ULNRC-05280

**DOCKET NUMBER 50-483
CALLAWAY PLANT
UNION ELECTRIC COMPANY
PROPOSED REVISION TO TECHNICAL SPECIFICATION 3.7.2
"MAIN STEAM ISOLATION VALVES (MSIVs)" AND REVISION TO
TECHNICAL SPECIFICATION 3.7.3 "MAIN FEEDWATER ISOLATION
VALVES (MFIVs) and MAIN FEEDWATER REGULATING VALVES
(MFRVs) and MAIN FEEDWATER REGULATING VALVE BYPASS
VALVES (MFRVBVs)" TO REMOVE VALVE ISOLATION TIME
FROM TECHNICAL SPECIFICATIONS
(LICENSE AMENDMENT REQUEST OL 1255)**

MARKUP OF TECHNICAL SPECIFICATION PAGES

Figure 3.7.3-1 (page 1 of 1)
MFIV Stroke Time Limit vs Steam Generator Pressure

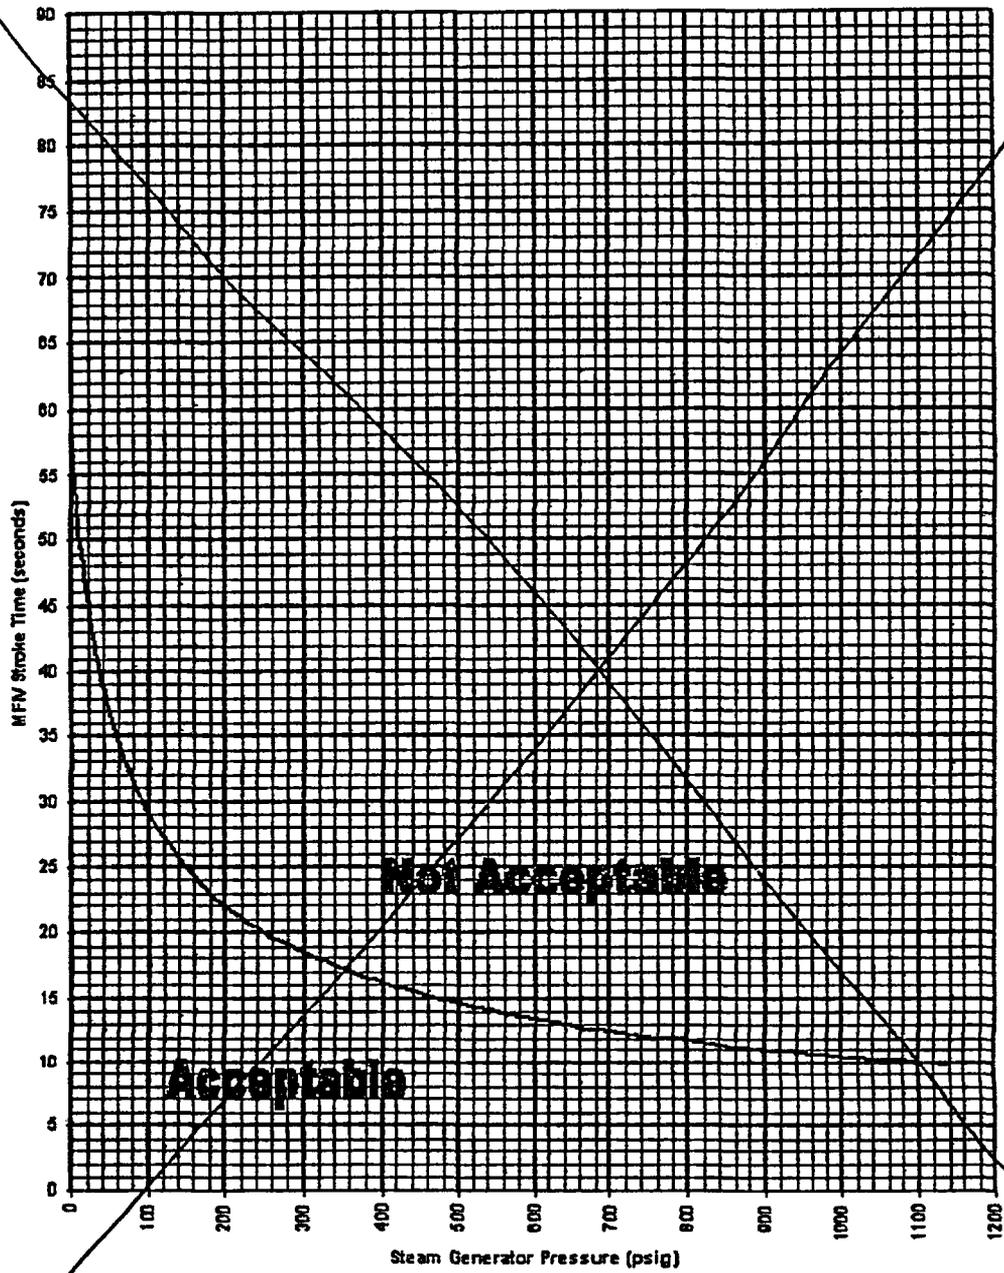
TS SR 3.7.3.3 currently states "Verify the closure time of each MFIV is within the limits of Figure 3.7.3-1." Proposed TS SR 3.7.3.3 states "Verify the closure time of each MFIV is within limits." The proposed change removes the specific reference to Figure 3.7.3-1 from SR 3.7.3.3 and relocates the TS Figure to the TS Bases.

The proposed change to SR 3.7.3.3 removes the reference to TS Figure 3.7.3-1 from the SR and relocates the Figure 3.7.3-1 to the TS 3.7.3 Bases. Although the traveler contemplates the relocation of single value acceptance criteria for valve isolation time,

| SURVEILLANCE | FREQUENCY |
|--|--|
| <p>SR 3.7.3.3</p> <p>Verify the closure time of each MFIV is within the limits of Figure 3.7.3.1.</p> | In accordance with the Inservice Testing Program |

the relocation of Figure 3.7.3-1 to the TS Bases is applicable. As discussed in Section 3.2 above, the MFIV actuator is a system-medium actuator that is dependent on steam generator steam pressure. SR 3.7.3.3 provides a stroke time test requirement more appropriate to the MFIV system-medium actuator design and its associated system-pressure dependent stroke time. TS Figure 3.7.3-1 is a curve of the MFIV isolation time limit as a function of steam generator steam pressure, in lieu of a single-valued stroke time limit. Evaluations were performed and concluded that a variable MFIV isolation time is acceptable with respect to the accident analyses. Meeting the MFIV isolation times in Figure 3.7.3-1 ensures the accident analyses remain valid. As such, the relocation of the specific values for valve stroke time (single value acceptance criteria or variable acceptance criteria) would not impact TS requirements that the Main Steam and Main Feedwater System isolation valves test within limits.

Figure B 3.7.3-1

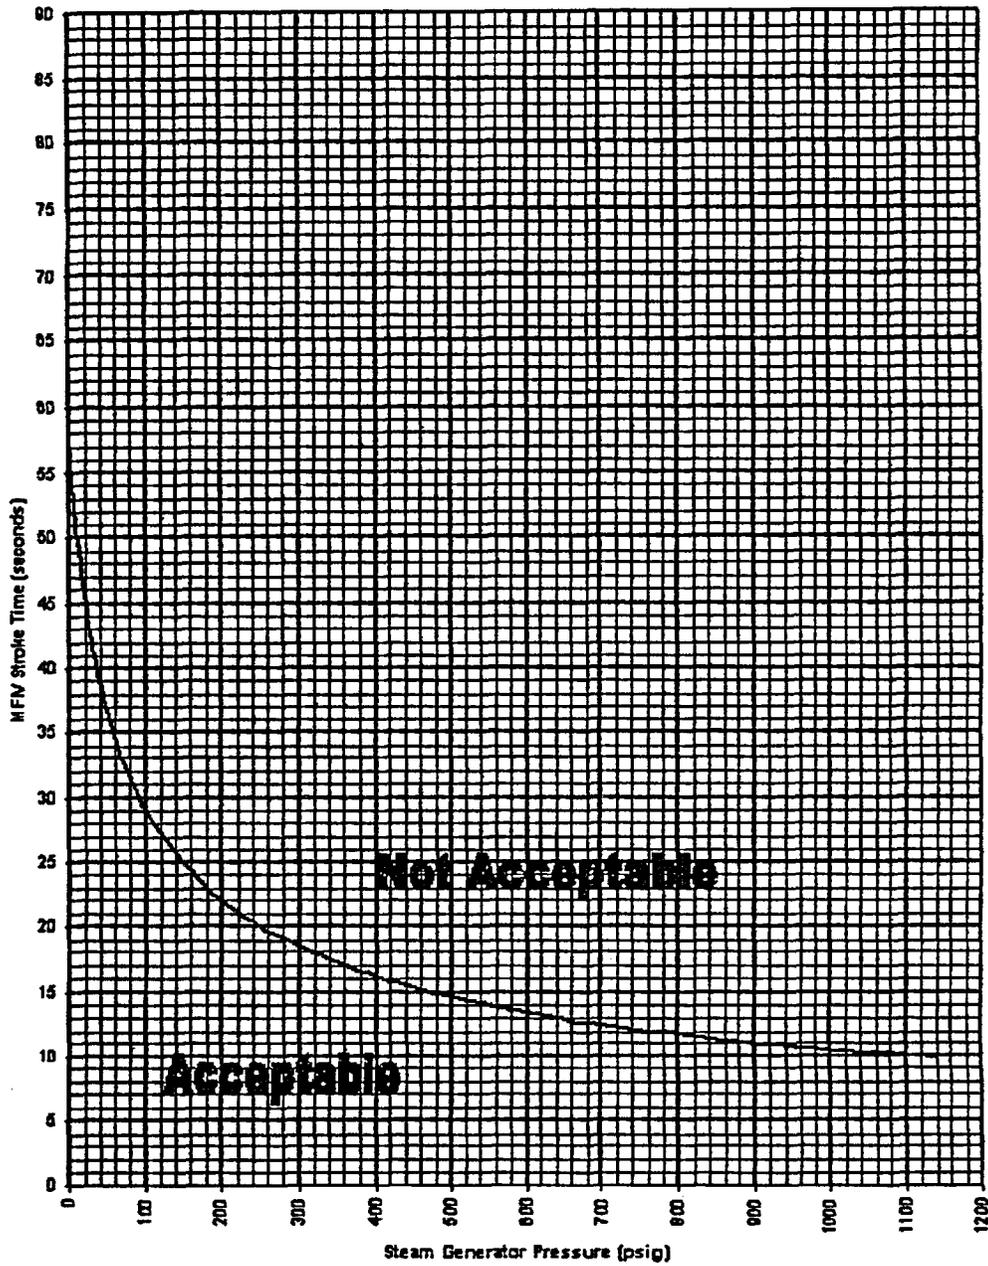
The impact of an MFIV isolation time as a function of steam generator steam pressure on the safety analyses has been evaluated in Reference 2 and 7. The evaluation concluded that a variable MFIV isolation time is acceptable with respect to the safety analyses. Figure B.3.7.3-1 is a curve

of the MFIV isolation time limit as a function of steam generator steam pressure. Meeting the MFIV isolation times in Figure 3.7.3-1 ensures that the evaluations performed in Reference 2 and 7 remain valid.

← INSERT
FIGURE B 3.7.3-1 →
TSBCN 04-015

This SR verifies that the closure time of each MFIV is within the limits of ~~Figure 3.7.3-1~~ from each actuation train when tested pursuant to the Inservice Testing Program. The MFIV closure time is assumed in the accident and containment analyses. ~~Figure 3.7.3-1~~ is a curve of the MFIV isolation time limit as a function of steam generator steam pressure, since there is no pressure indication available at the MFIVs. The acceptance curve for the MFIV stroke time conservatively accounts for the potential pressure differential between the steam generator pressure indication and the pressure at the MFIVs. Meeting the MFIV isolation times in ~~Figure 3.7.3-1~~ ensures that the evaluations performed in Reference 2 and Reference 7 remain valid. This Surveillance is normally performed upon returning the unit to operation following a refueling outage. These valves should not be tested at power since even a partial stroke exercise increases the risk of a valve closure with the unit generating power.
